STAFF RECOMMENDATION 211 South 13th Street October 16, 2019

Application: New Construction--Addition
District: Lockeland Springs-East End Neighborhood Conservation Zoning Overlay
Council District: 06
Base Zoning: R6
Map and Parcel Number: 08313005100
Applicant: Jonathan Jones
Project Lead: Paul Hoffman; paul.hoffman@nashville.gov

Description of Project: This application is for construction of a rear addition to the historic home.

Figures 4-5: As drawn, the addition consumes this existing roof plane indicated. Staff recommends the roof be revised to leave this existing roof form.

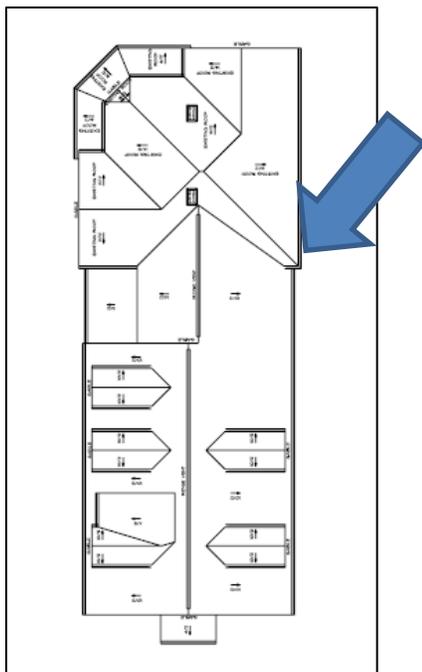
Roof form: The historic home has a hipped roof with a rear-facing gable. The addition connects to the house at the existing gabled portion leading to the primary form of the addition, a gabled roof form with 10/12 pitch. On the building’s right side, the same roof plane remains in place. On the left side of the building, the addition’s roof pitch changes, and the new roof replaces the existing roof and porch roof. Staff does not find this amount of change appropriate as it is too much alteration of an original roof form (Figures 4 and 5). Staff recommends that the addition’s roof be revised to maintain the roof of this portion of the historic home.

With the conditions that the addition's roof is revised on the left side to keep this existing roof intact, and the dormer is redesigned to meet the proportion, shape and glazing of historic dormers, the addition will meet Section II.B.5 for roof form.

Figures 6: Staff recommends redesign of this dormer on the addition's right side.

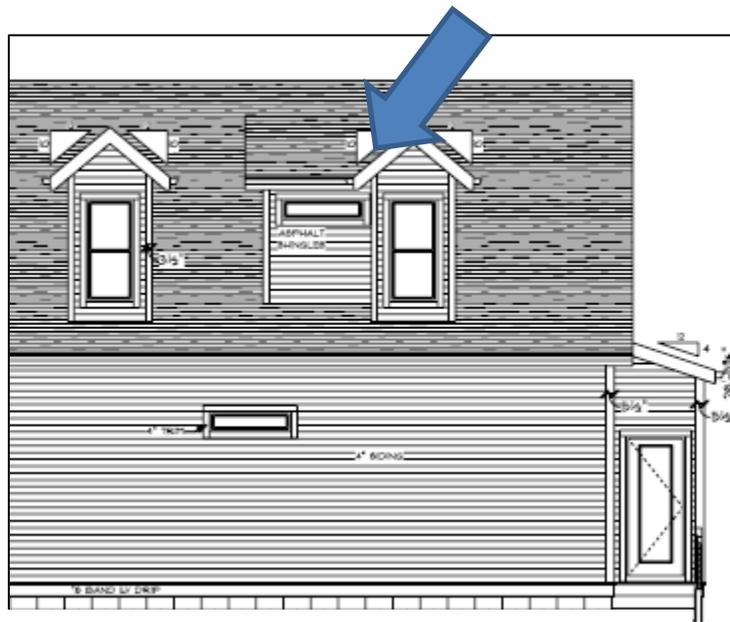
Additionally there are dormers on each side of the addition. The rearmost dormer on the right side has an attachment that is not seen historically (Figure 6). The face of the dormer is not primarily glazing, as seen historically and as has been required by the commission in the past. Staff recommends that this dormer be redesigned into a more traditional design and proportion.

Proportion and Rhythm of Openings: The windows on the proposed addition are generally twice as tall as they are wide, meeting the historic proportions of openings, however there are two horizontal windows on the

right side. One is in the dormer for which staff is recommending redesign (see Roof Form). The second is on the ground floor below. The fenestration of this area is not compatible with the window pattern of historic buildings. In most cases, every eight to thirteen feet (8-13') of wall surface should have an opening. Staff therefore recommends that traditionally-proportioned windows are added to this façade to meet this requirement.
